IN THE DRAWINGS:

In response to the Notice Regarding Drawings mailed July 17, 2006 herein, corrected Figs. 11, 15 and 20, each labeled "Replacement Drawing," are supplied herewith and originals of those figures are supplied with annotations indicating the changes made therein, in producing the corrected figures.

RESPONSE TO NOTICE REGARDING DRAWINGS**TRAVERSE TO INDICATION THAT FIG. 20 DOES NOT SATISFY THE "VIEWS" REQUIREMENT UNDER 37 C.F.R. 1.84 (h)**

FIG. 11

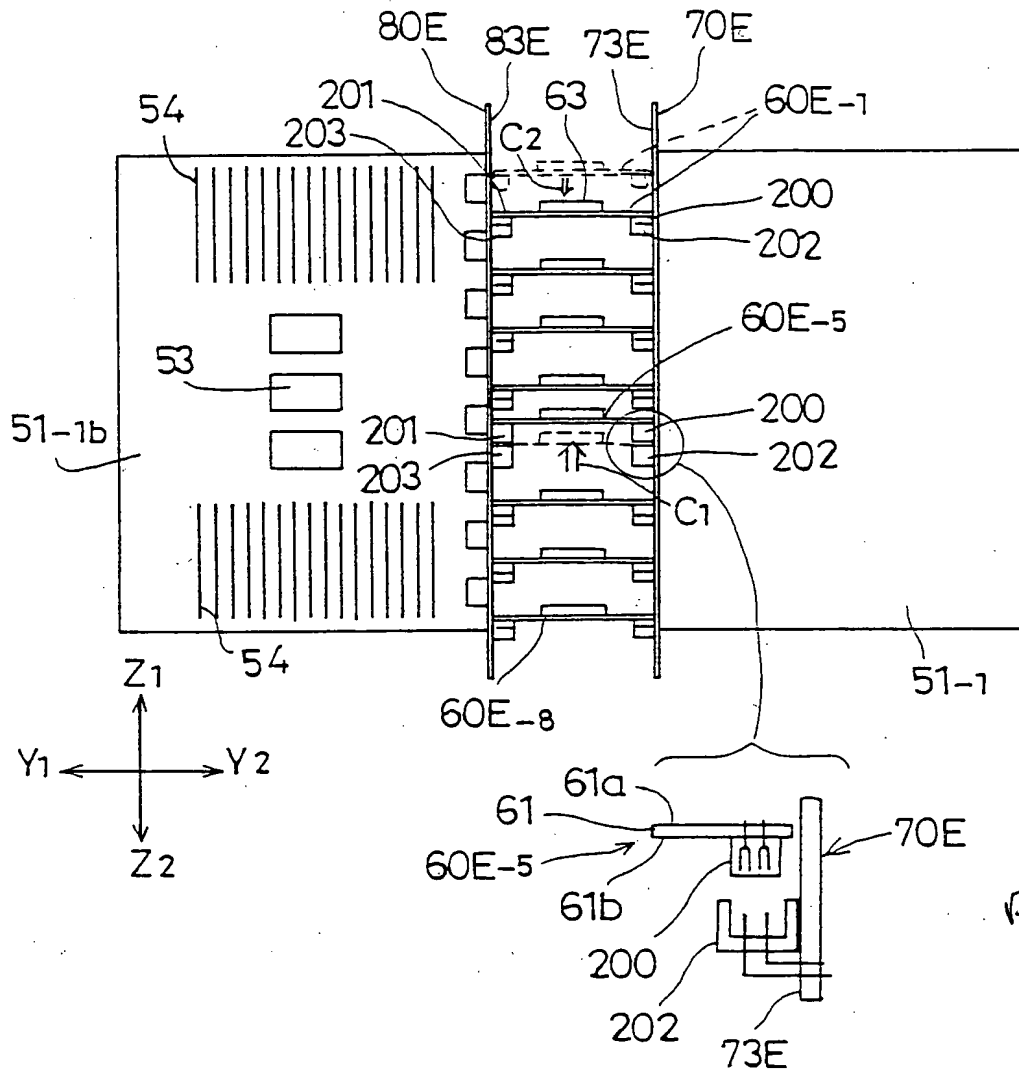
In the sheet containing Fig. 11, a new legend Fig. 11-1 has been placed adjacent the separately illustrated structure disposed below (in the Z2 direction) the main structure illustration of Fig. 11, the enlarged structure of Fig. 11-1 corresponding to the portion of the structure of Fig. 11 designated by a circle in the original Fig. 11.

Fig. 11 has been further labeled with - - Fig. 11-1 - - beside the elements in the bracketed grouping at the bottom of Fig. 11, which corresponds to an enlarged view of the same such elements 200 and 202 in the encircled portion of the structure shown in the upper portion of the sheet bearing Fig. 11.

FIG. 15

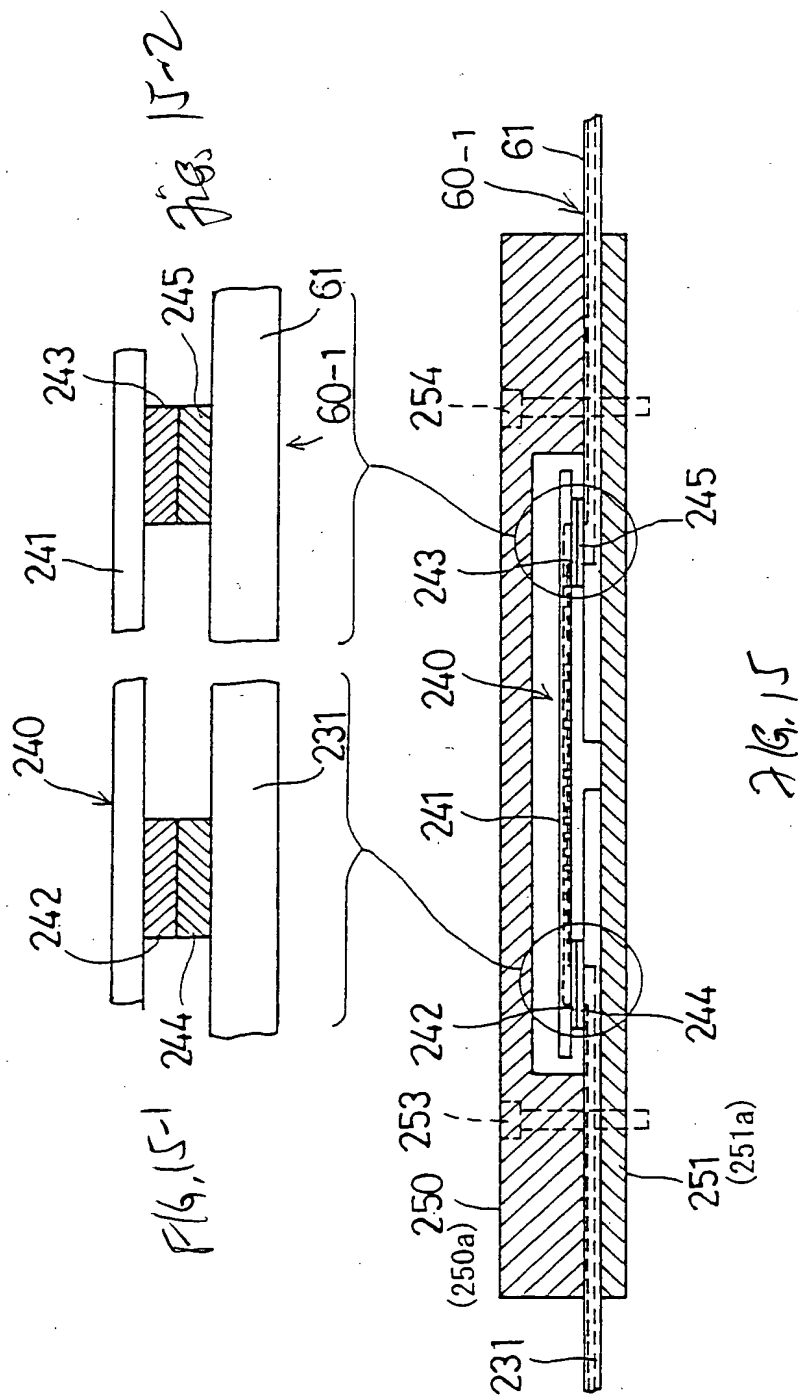
Fig. 15 has been corrected by moving the legend "Fig. 15" to the bottom of the page adjacent the completed structure as originally illustrated at that location and new legends Fig. 15-1 and Fig. 15-2 are placed to the left and right respectively, of the enlarged portions of the structures identified by circles, overlaid on the structure of Fig. 15.

The sheet containing Fig. 15 has been modified to include labels "15-1 and 15-2" respectively presenting the enlarged views of a stacking connector 240 and a flat-cable unit 241 corresponding to respective portions of those same encircled elements as illustrated in the lower Fig. 15 structure. (To accommodate the use of the new Figs. 15-1 and 15-2 labels, the original Fig. 15 label has been relocated to the bottom of the page adjacent the lower structure.

As before noted, "Fig. 15" has been moved to the bottom of the page adjacent the complete structure illustrated on that page and new designations Fig. 15-1 and Fig. 15-2 are placed adjacent the left and right structures which illustrate on an enlarged scale the corresponding structure and circled in the Fig. 15 illustration.

The Brief Description of the Drawings at page 11, lines 1-2, has been supplemented to recite, after "Fig. 14" and before the "semicolon" the further description that - - , Fig. 15-1 is an enlarged view of the stacking connector 240 and Fig. 15-2 is an enlarged view of the flat -cable unit 241 which respectively appear in corresponding, circled portions of the structure illustrated in Fig. 15.
